DOCKETED	
Docket Number:	15-AFC-01
Project Title:	Puente Power Project
TN #:	215583
Document Title:	Department of the Navy, Naval Base Ventura County, Comments on 15-AFC-01 Puente Power Plant Final Staff Assessment
Description:	Naval Base Ventura County comments on Traffic and Transportation section of Puente Power Project AFC
Filer:	Jonathan Fong
Organization:	Department of the Navy
Submitter Role:	Public Agency
Submission Date:	1/26/2017 1:03:13 PM
Docketed Date:	1/26/2017

SUBJECT: DOCKET NO. 15-AFC-01 PUENTE POWER PLANT FINAL STAFF ASSESSMENT

Enclosures: 1. Naval Base Ventura County Point Mugu Air Traffic Control Radar Screen

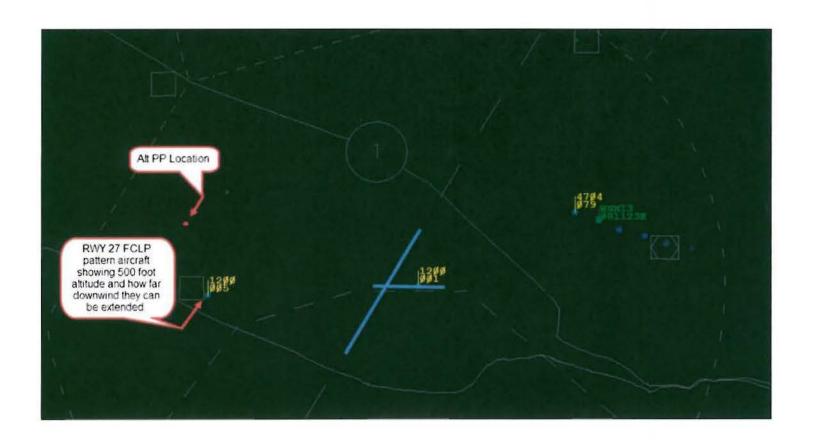
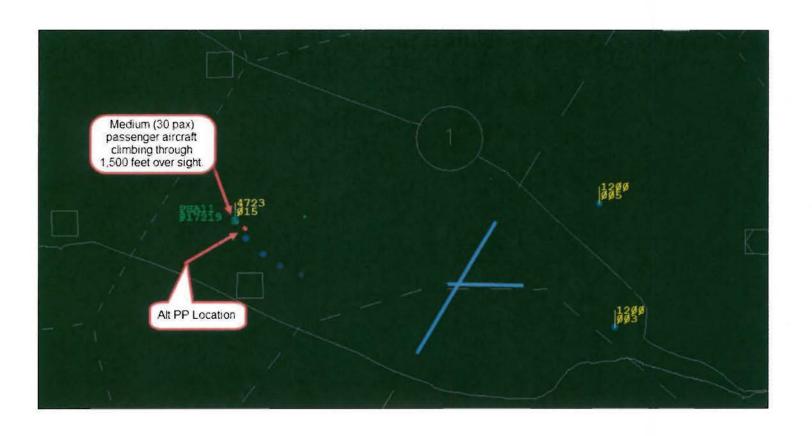
Additionally, as shown in the attached ATC radar screen captures, medium-sized passenger aircraft depart Runway 27 and regularly fly a path over or very near the Ormond Beach Off-Site Alternative Site while climbing between 1,000 and 3,000 feet AGL. These flights are capable of carrying 30 passengers,

occur 3-4 times each weekday, and serve as a critical linkage to military operations at NBVC San Nicolas Island and Naval Air Weapons Station China Lake.

Our analysis indicates that the proposed project stack height of 188 feet would likely be determined by the FAA to not pose an obstruction hazard to Point Mugu operations at the Ormond Beach Off-Site Alternative Site. However, our analysis of departure tracks indicate that the resulting thermal plume could pose a significant hazard to small and medium sized aircraft on departure from Runways 27 and 21 as they make departure turns very near or over the Alternative site while climbing between 1,000 and 3,000 feet. Per FAA Memorandum on Technical Guidance and Assessment Tool for Evaluation of Thermal Exhaust Plume Impact on Airport Operations dated September 24, 2015, the FAA has also determined that thermal exhaust plumes are incompatible with airport operations in the vicinity of airports and may pose unique hazards to aircraft in critical phases of flight, particularly during takeoff, landing and within the pattern, which are the operations NBVC is concerned about.
